SANITARY SURVEY REPORT

January 12, 2022	Estates Inc. Water System ID #081669	
Dale Metzger Estates Inc. Post Office Box 92 Sequim, Washington 98382	County:	Clallam
	System Type:	Community
	Operating Permit Color:	Green
	Surveyor:	Jocelyne Gray
	Water System Attendees:	Dale Metzger Culley Lehman
	County Health Attendees:	Sue Waldrip Ben Majors
	Inspection Date:	December 8, 2021

Well 1 With Sealed Wires

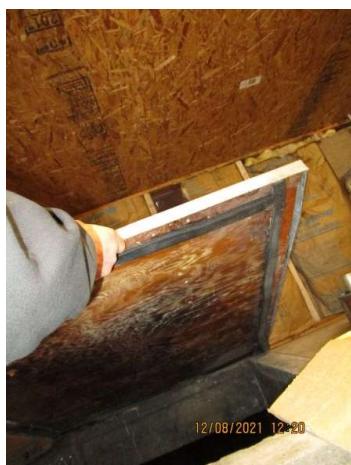
1. Electrical wires entering Well 1 needs to be sealed. Wires were sealed during inspection.

Electrical wires entering Well 1 need to be sealed. Wires were sealed during inspection.
